ADDENDUM #2

NOTICE TO ALL BIDDERS FOR
CITY OF WINCHESTER

ITB #202005 – Valley Avenue Improvements

PROJECT	SHEET NO.
U000-138-R04	20(7)

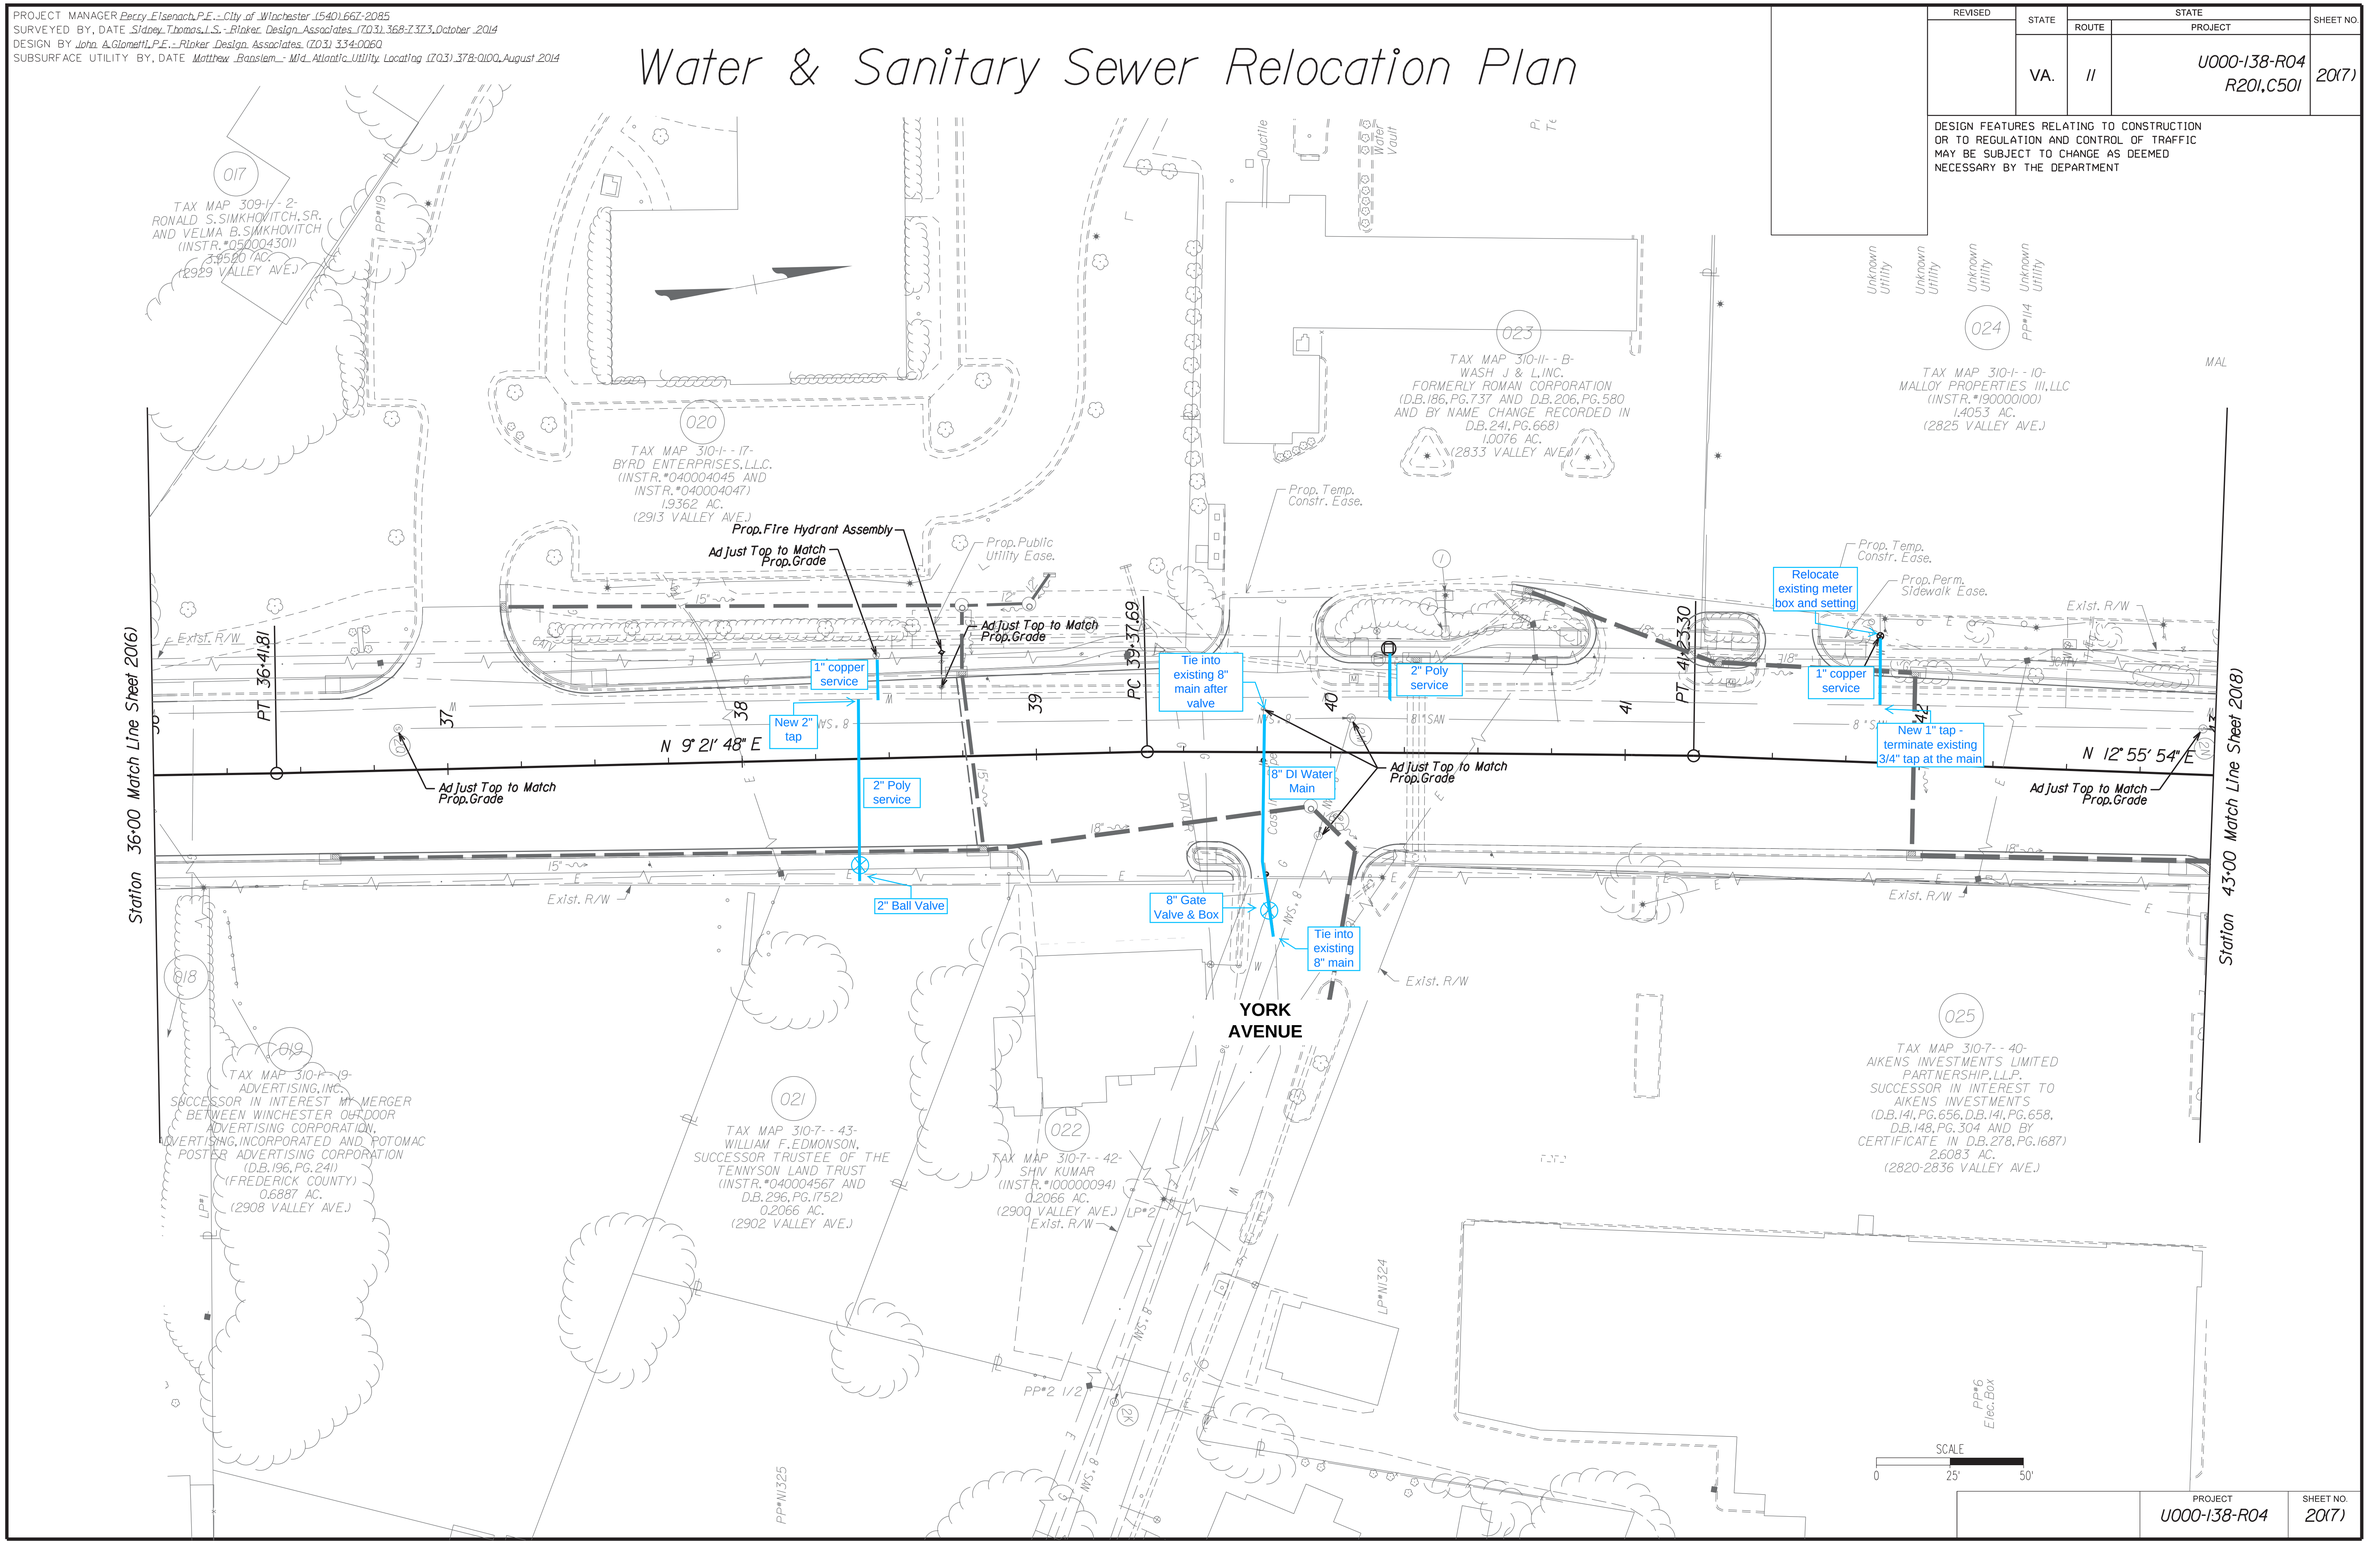
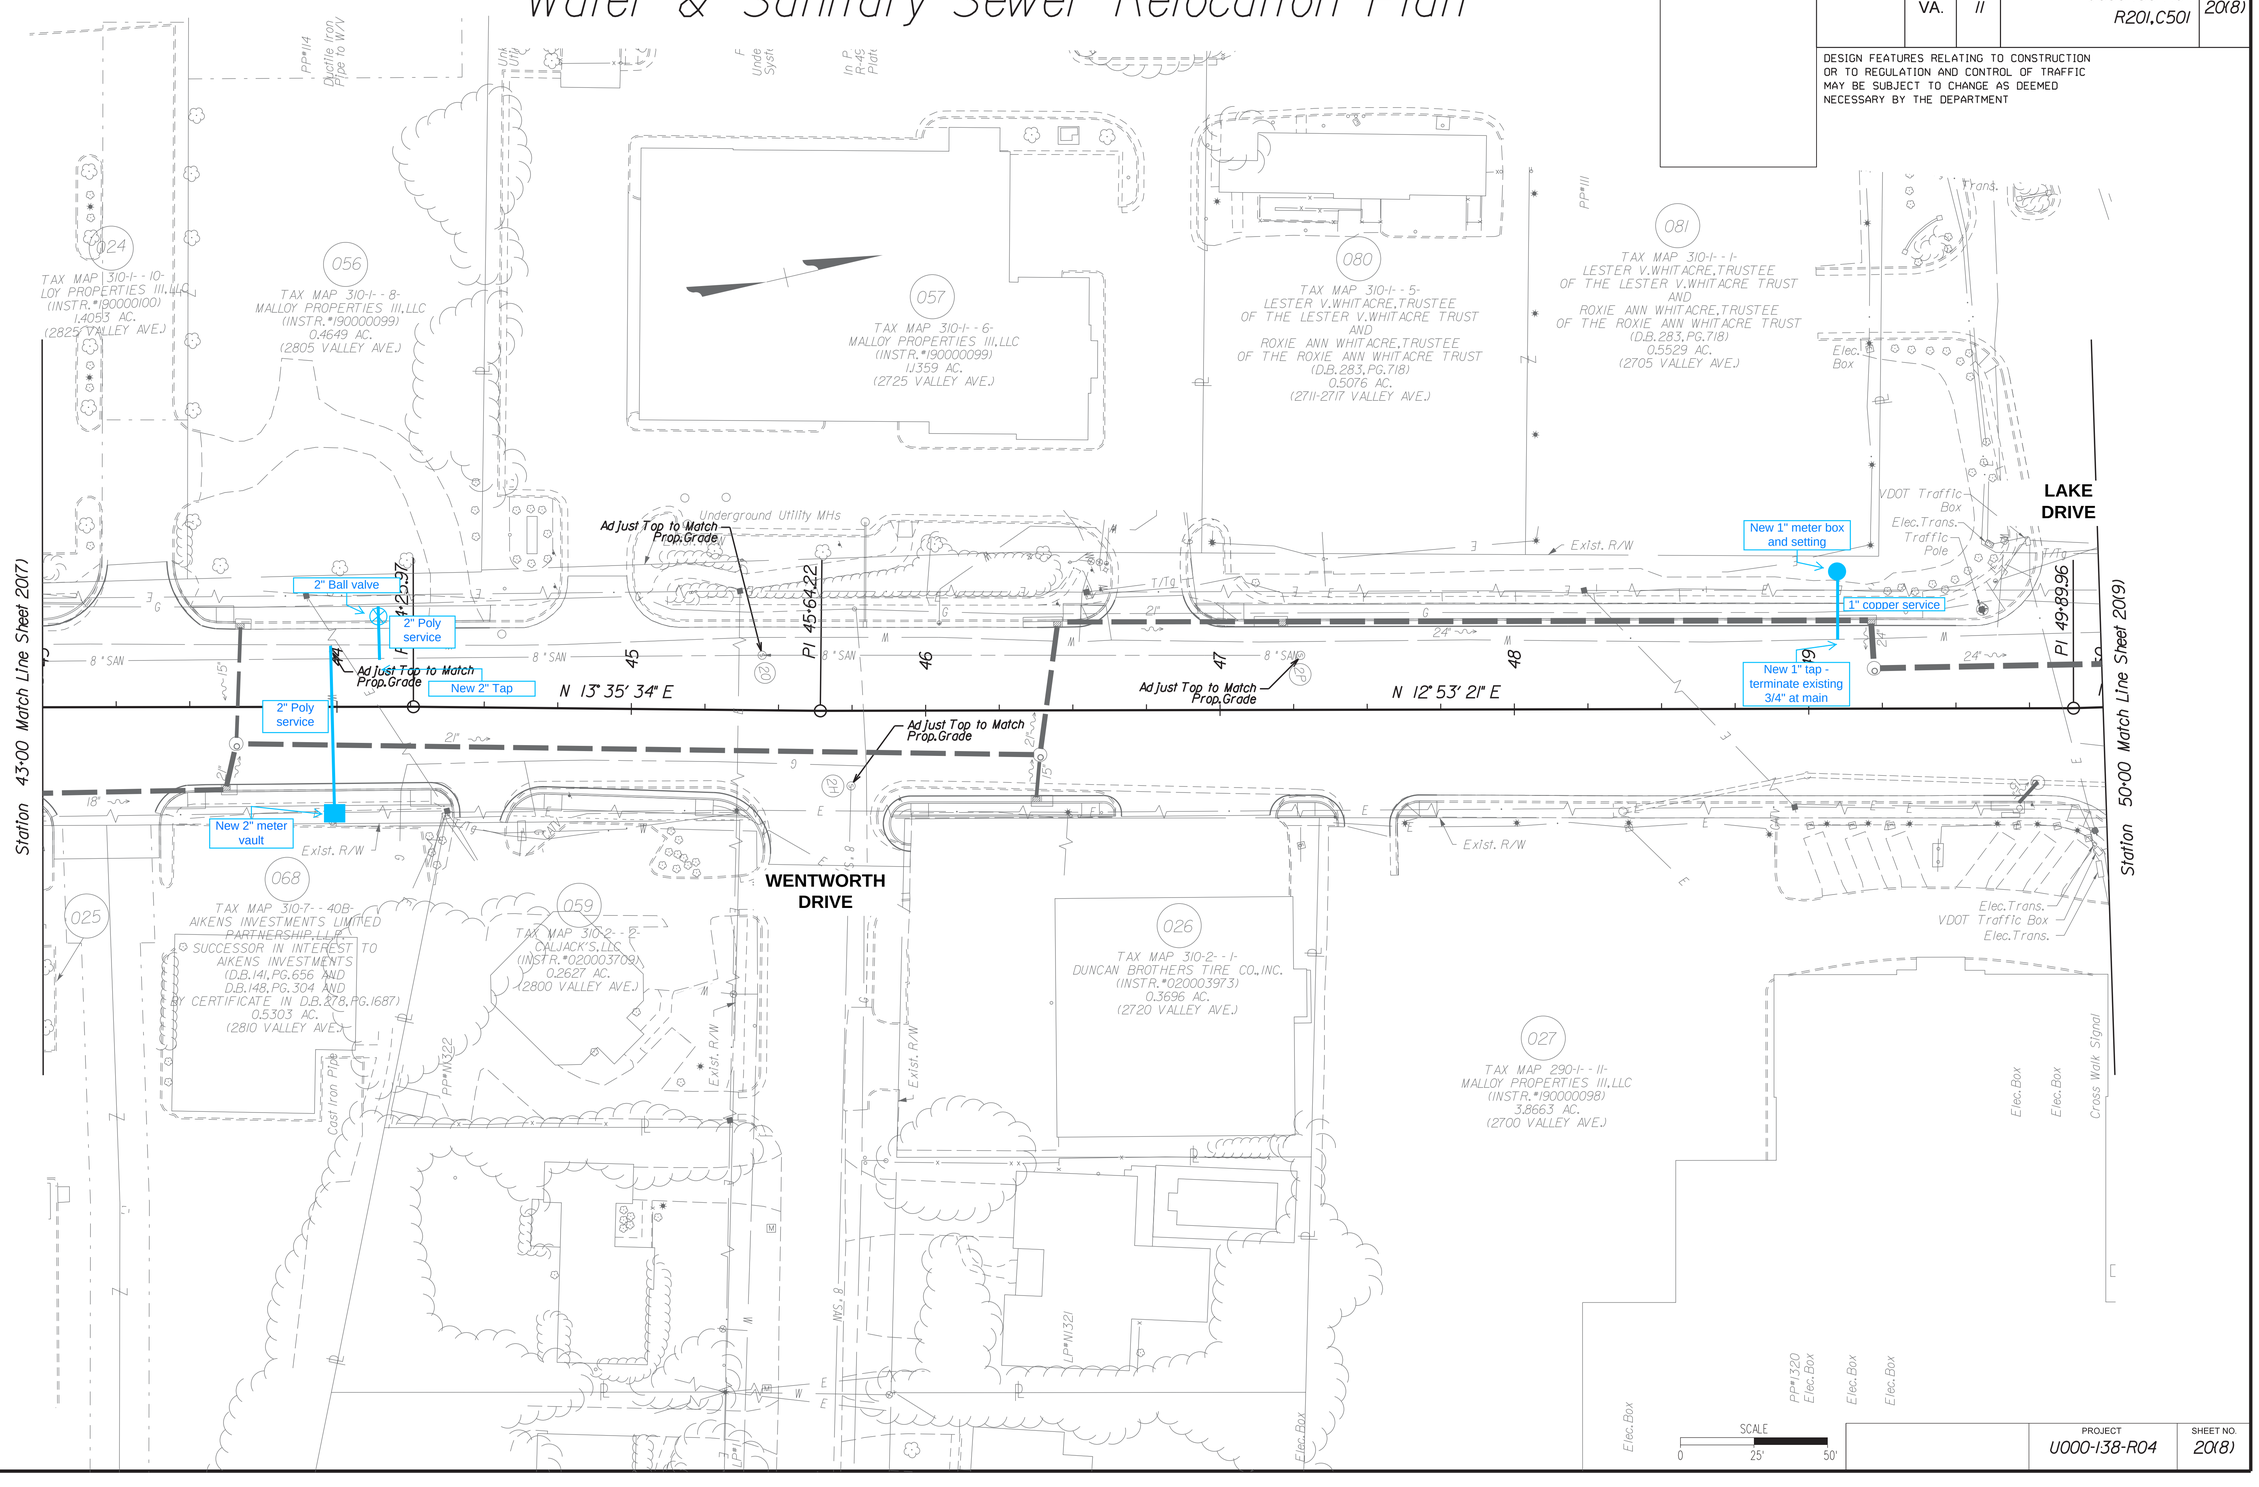
6. There have been numerous additions made to the water and sewer replacements for this project that are included in the revised Bid Form. The original plans have been modified with color showing this information and are attached.
